- SUBJECT:
1. Subdivision Modification to create six lots which have double street frontage
 2. Tentative Map (P-9339)

LOCATION: Southwest corner of Main Avenue and Norwood Avenue

A RESOLUTION ADOPTING FINDINGS OF FACT,
APPROVING A REQUEST FOR SUBDIVISION
MODIFICATION AND TENTATIVE MAP FOR
GLENWOOD PARK UNIT NO. 6 (APN: 237-020-13)
(P-9339)

TENTATIVE MAP
GLENWOOD PARK UNIT NO. 6

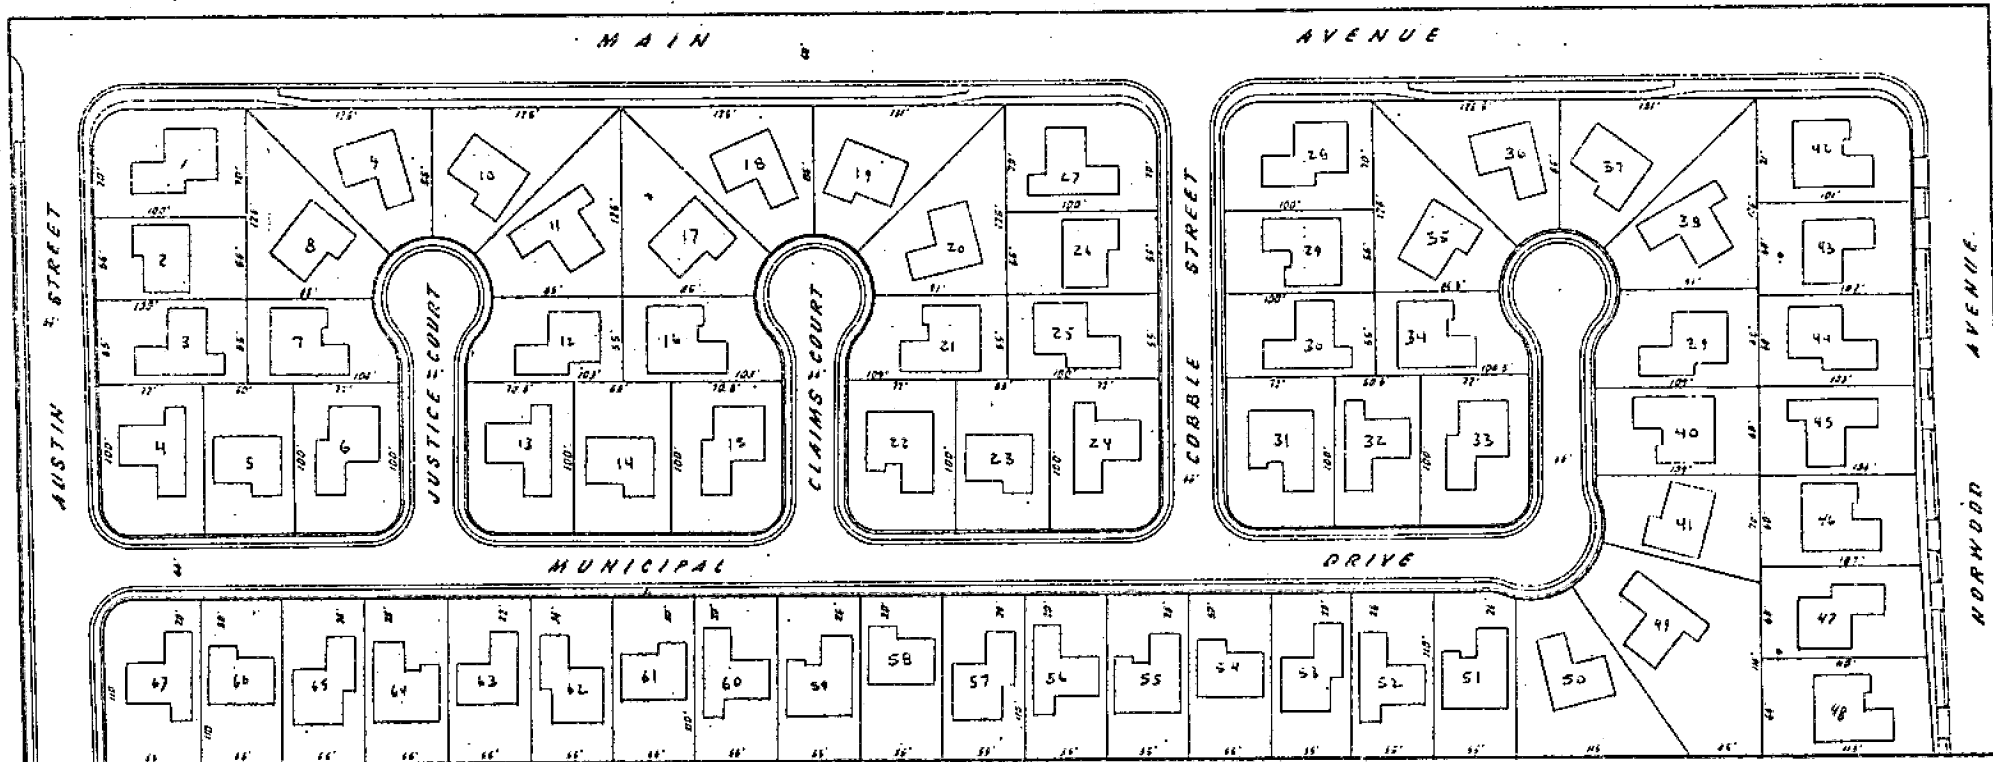
The present design achieves only a 28% north/south lot orientation. However by reorienting lots on the north side of proposed Municipal Drive (Lots 3-6, 11-14, 19-21 and 27-30 of the applicant's proposal), forty-five percent (45%) of the lots have side property lines that are oriented within 22½% of true north.

Due to concerns regarding front on lots along Main Avenue, staff finds the possibility of achieving 80% north/south lot orientation infeasible. Staff, therefore, requests that the applicant be required to orient at least 23 units to face north/south in order to allow solar glazing. This will achieve the 80% north/south lot and/or unit orientation and will therefore be consistent with the policies of the General Plan.

2. Staff's proposed site plan (Exhibit "A") results in a yield of 65 lots, four more than the applicant's design. This brings the density to 4.3 dwelling units per acre, well within the density requirements of the R-1 zone.
3. The proposed subdivision design creates a linear street (Municipal Drive) that includes all 60' wide lots. This design has a tendency to create a "row" affect along the south side of this street. Staff suggests that a variation in lot width (55' to 65') and a variation in setbacks ranging from 25' to 35' in order to help break the row appearance of this street.

8. The final map shall indicate front setback lines for Lots 50 through 65 varying between 25 and 35 feet. (CPC amended to:..between 25 and 30 feet.)
9. The applicant shall submit plans for review and approval by the Planning Director for at least 23 of the east/west oriented lots demonstrating that the predominant structural glazing faces within 22½% of true south prior to issuance of any building permits.
